Re: 126 Main Street – Gas Station and Convenience Store
Response to 7/16/2025 PZA Memorandum

Re: 126 Main Street
Monroe, CT

This letter is in response to comments from the Town Engineer. The comments and the response are as follows:

SHEET NUMBER: **SP-1**

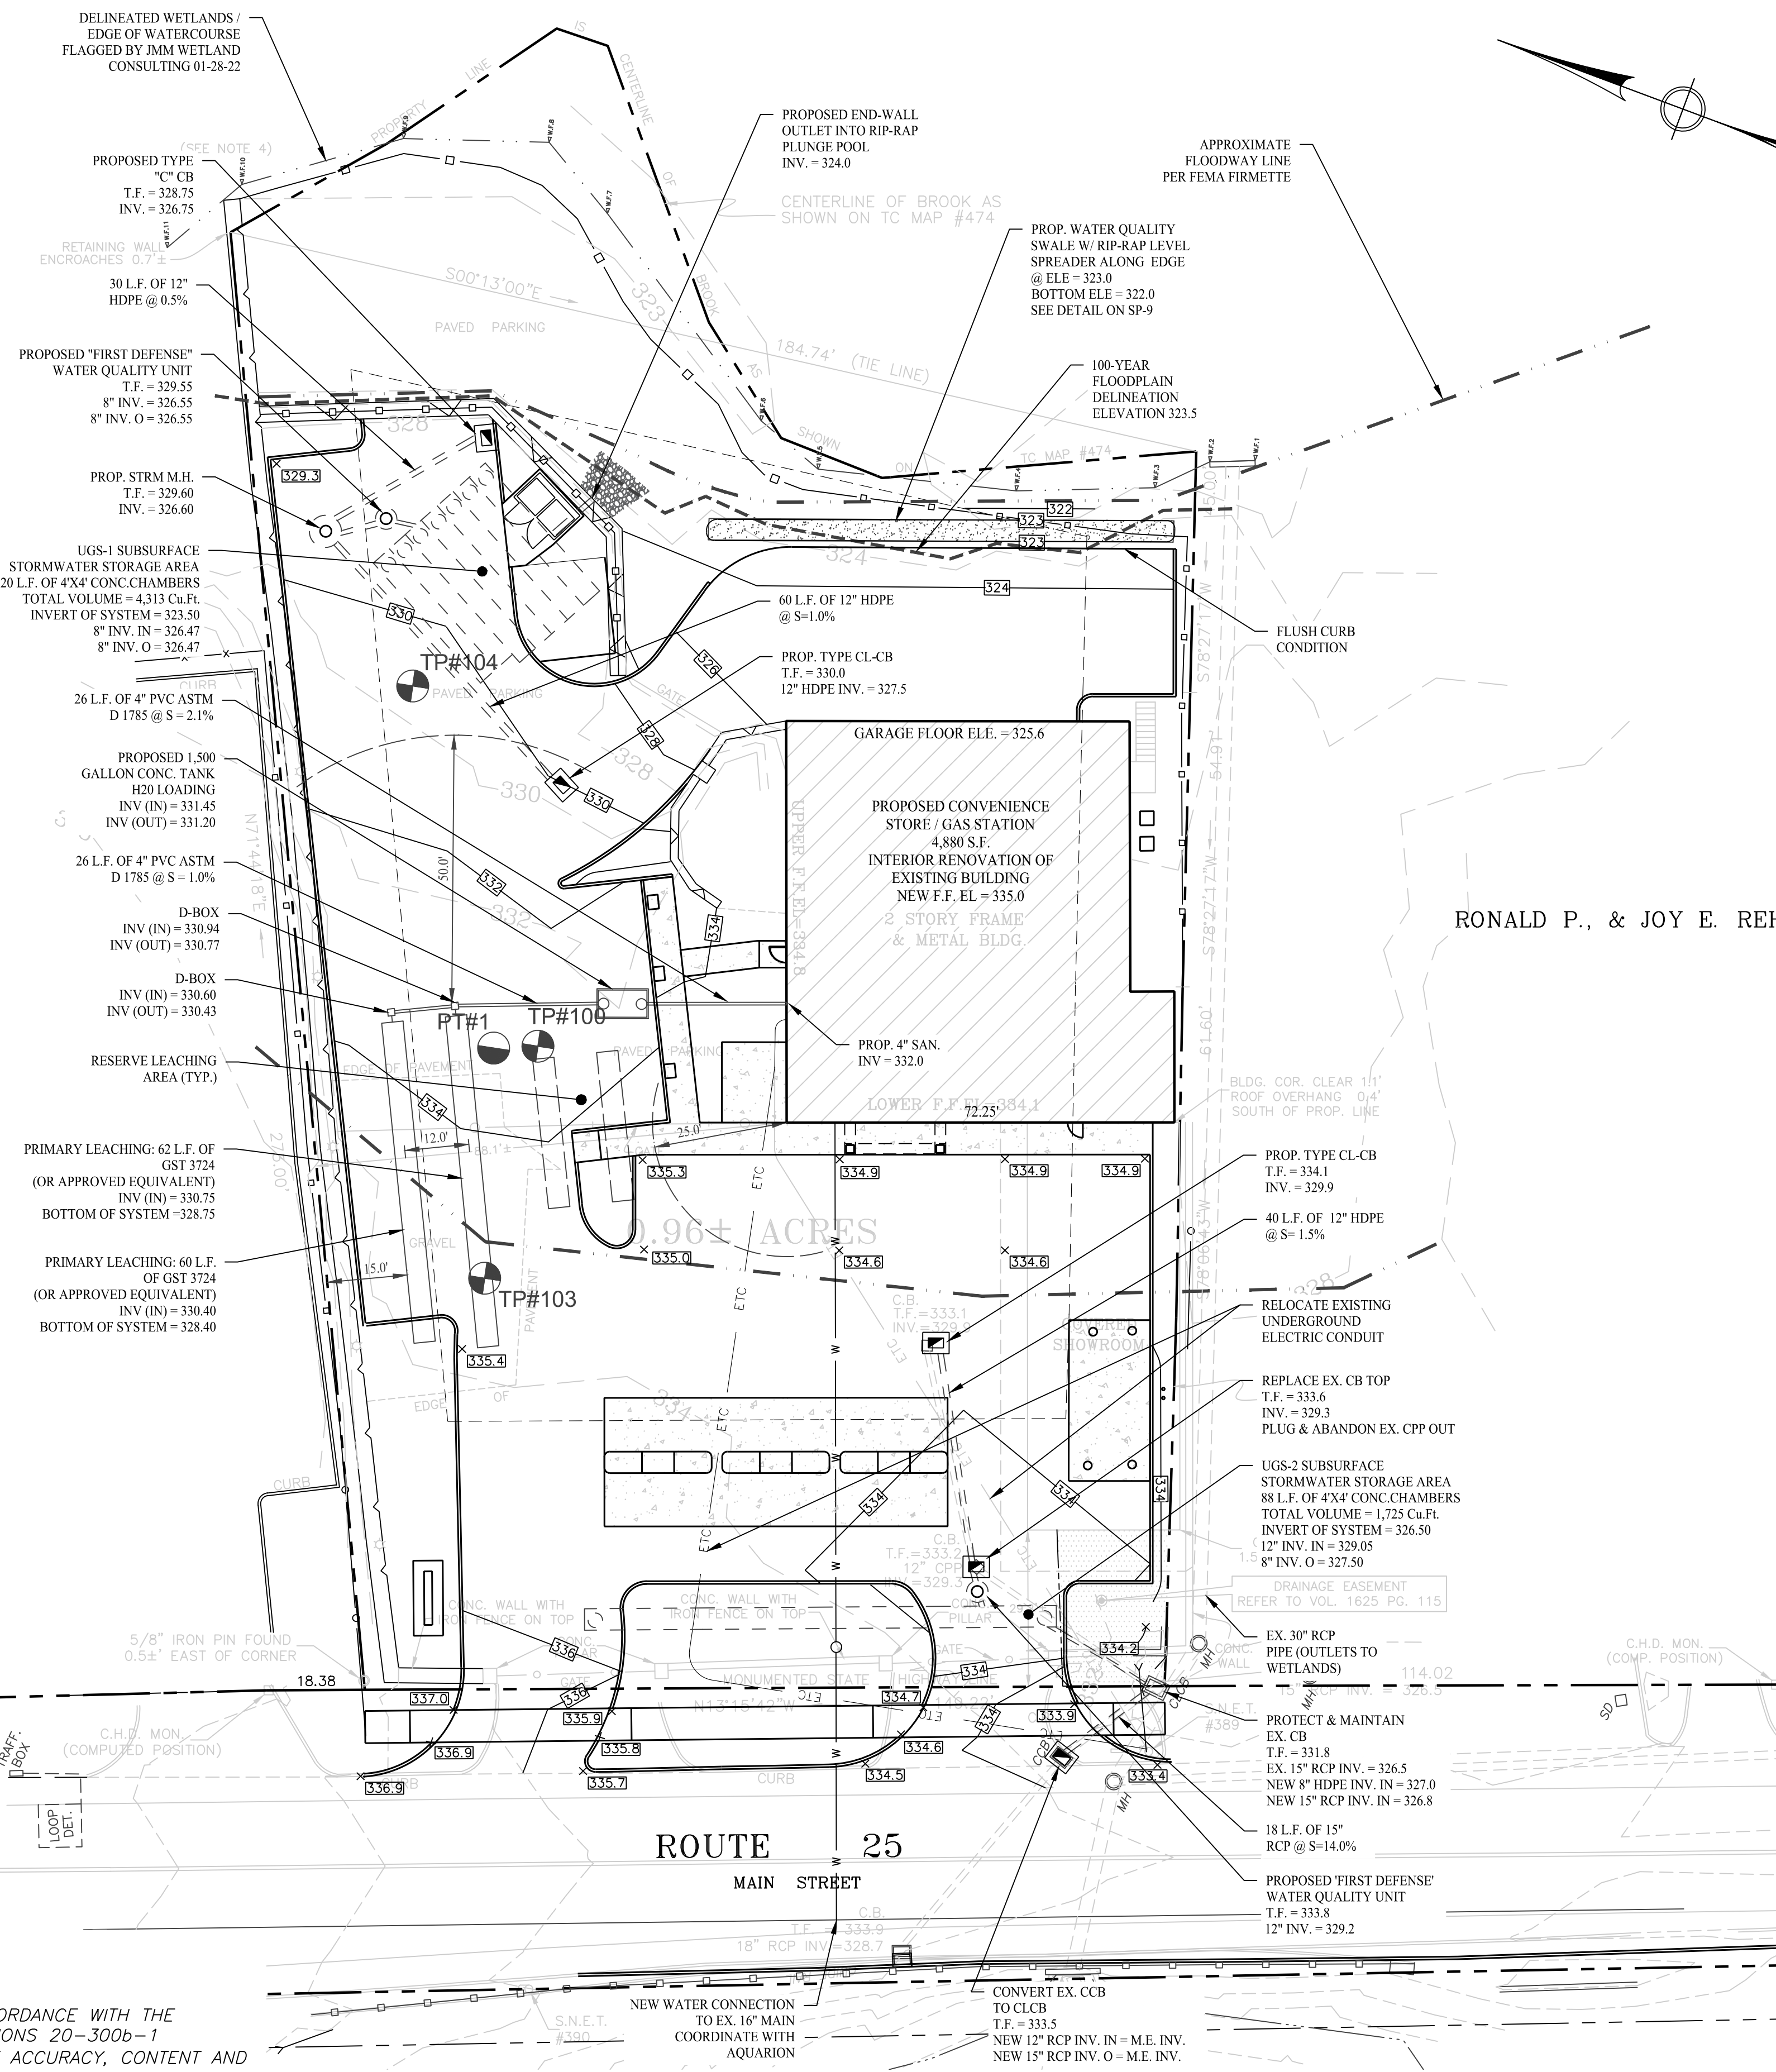
- d. *Approved CT DOT off-site improvements have been included in plans.*
2. Parking Regulations:
 - a. Please show dimensions and compliance with ToM Zoning Regulations §4.1.6 B “No parking areas or internal driveway shall be located less than twenty (20) feet from a street line, right-of-way line, or front property line, or within thirty (30) feet of a residence district.” This is concern with the driveway proximity to front property line. *See revised SP-1 20’ provided between front property line and internal driveway.*

- b. Charging Stations: Per Connecticut General Statutes §4b-77c “a municipality shall require each new construction of a commercial building or multiunit residential building with thirty or more designated parking spaces for cars or light duty trucks to include electric vehicle charging infrastructure that is capable of supporting level two electric vehicle charging stations or direct current fast charging stations in at least ten per cent of such parking spaces. A municipality may, through its legislative body, require any such commercial building or multiunit residential building to include such electric vehicle charging infrastructure in more than ten per cent of such parking spaces.” Please update the plans to show compliance. *See revised SP-1, 4EV charging spaces shown with two charging heads located.*

SP-5

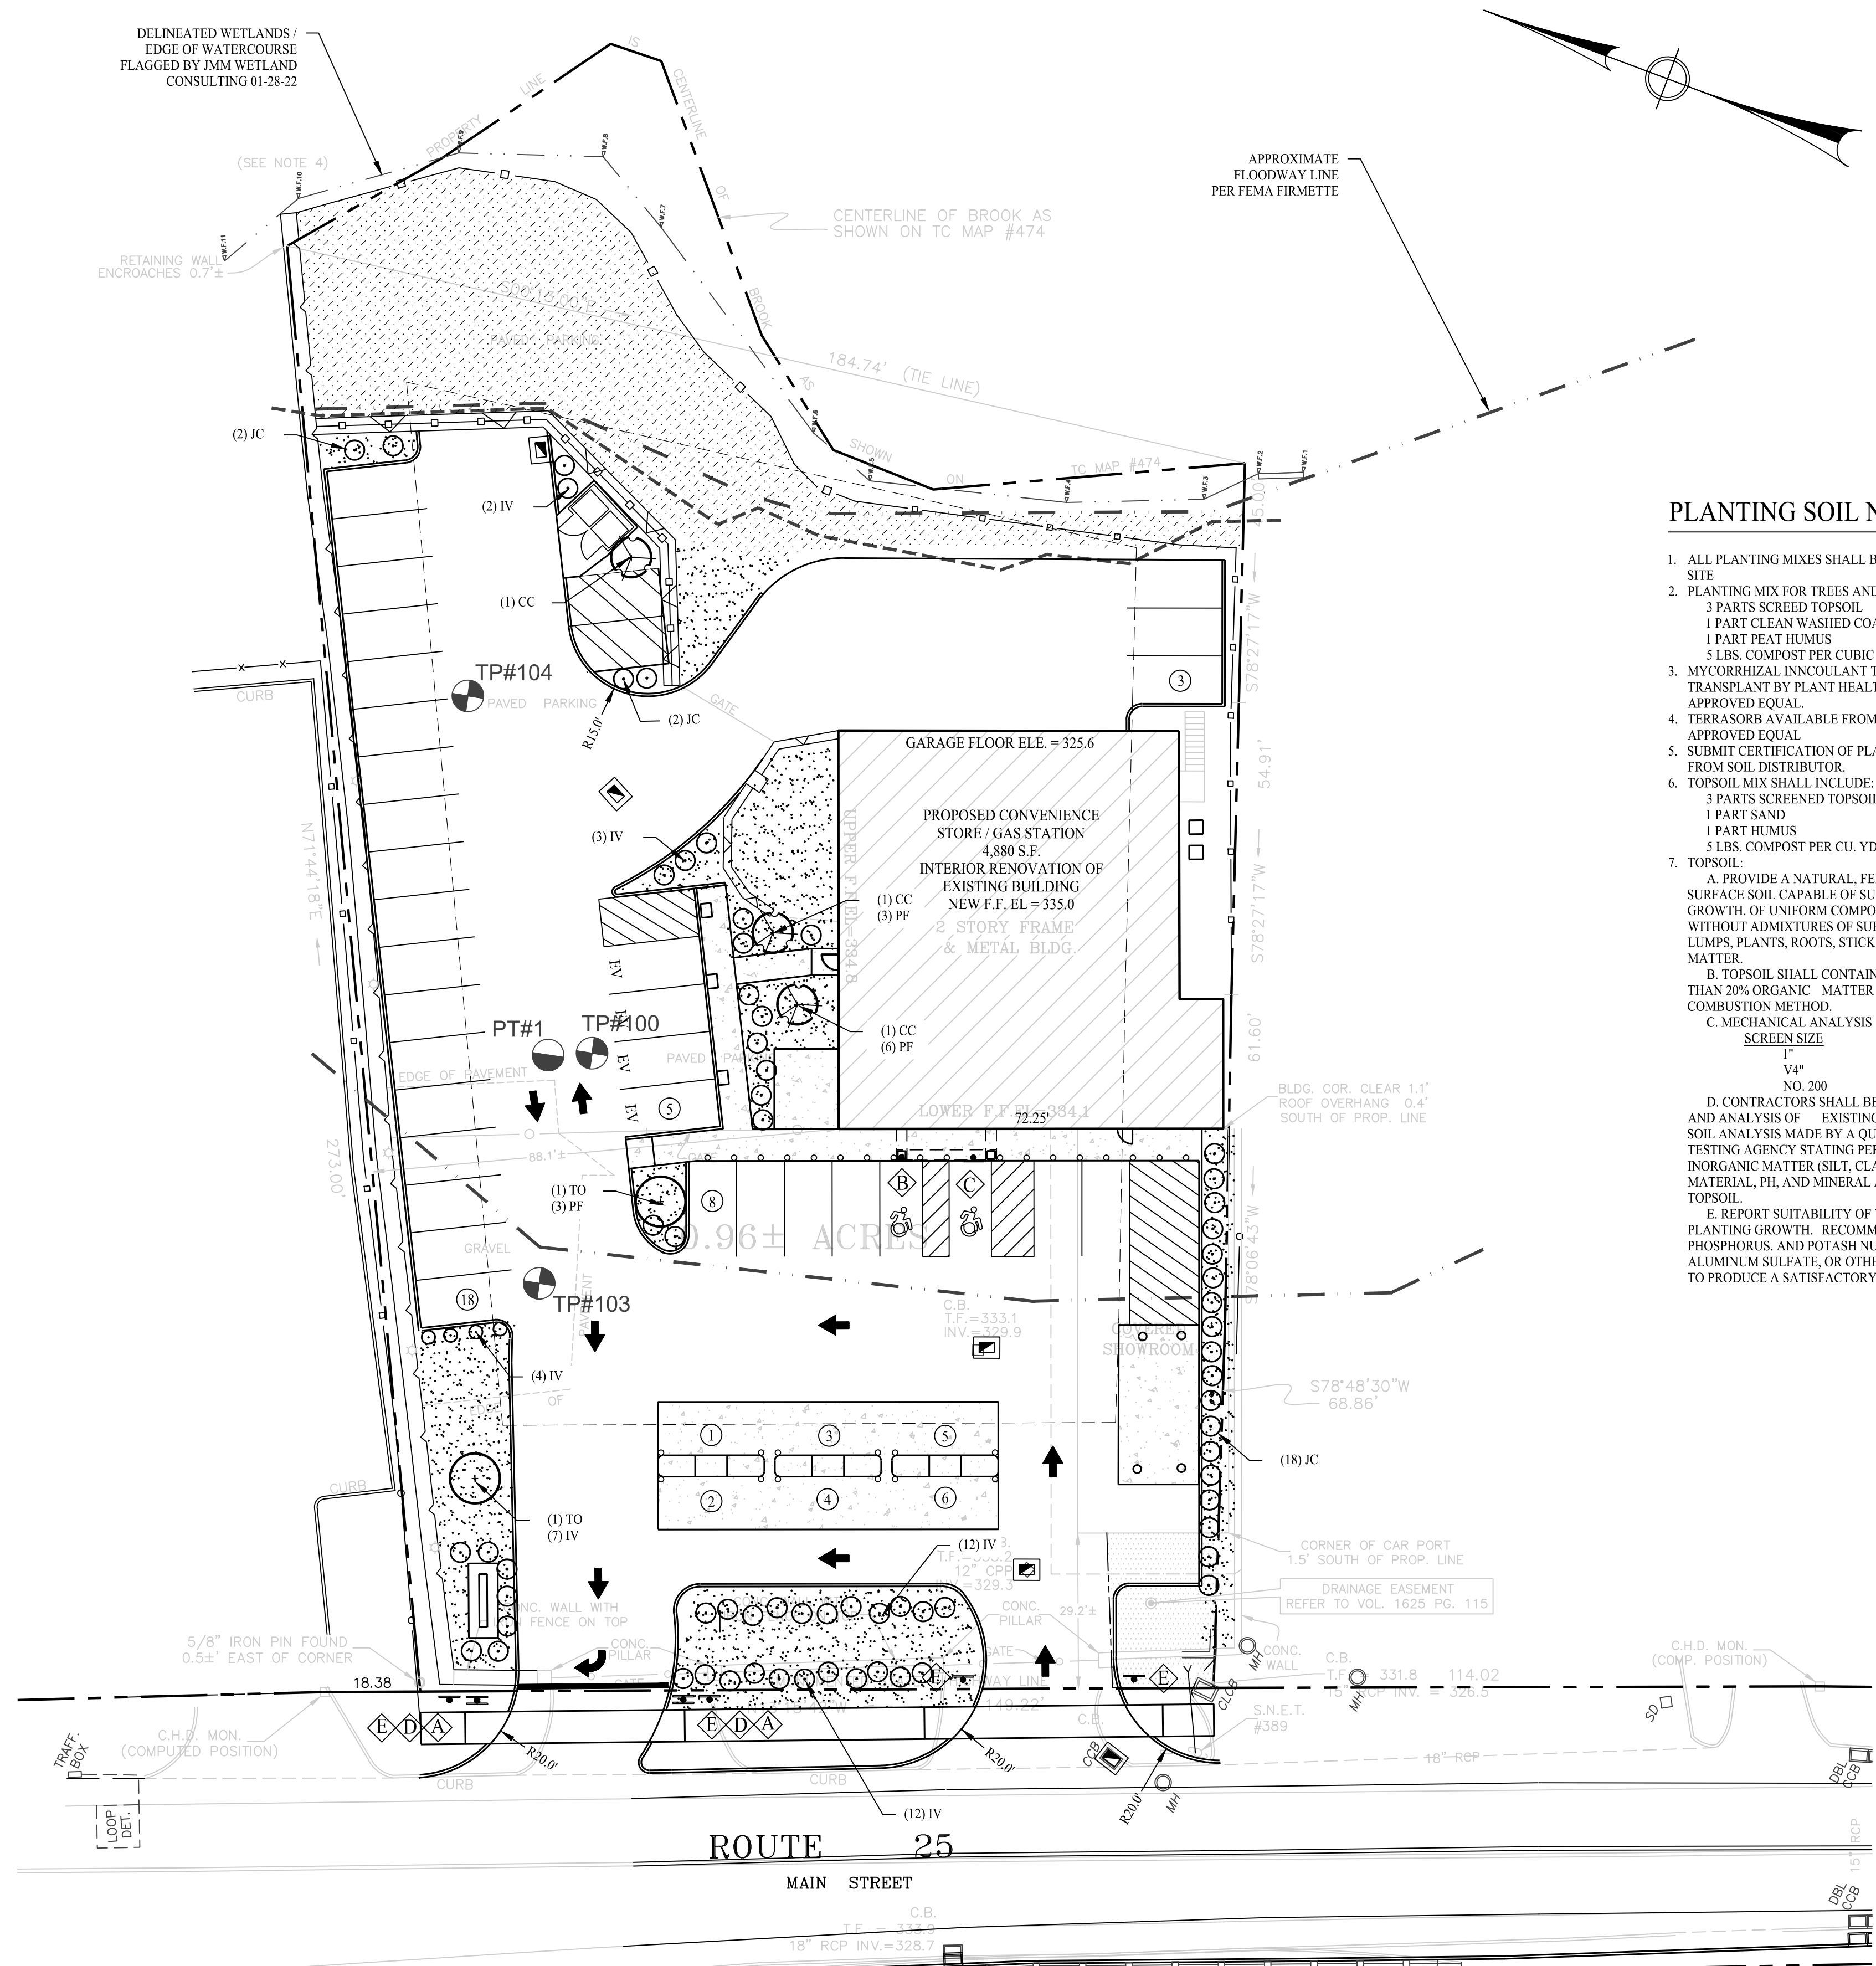
a. Per ToM Zoning Regulations §6.2.4 (2) "The minimum depth of the front yard landscape buffer for lots in B-1, B-2 and LOR Districts shall be no less than twenty (20) feet." Please show compliance with front yard landscape buffer.
See revised SP-5 for 20' of landscape at front yard.
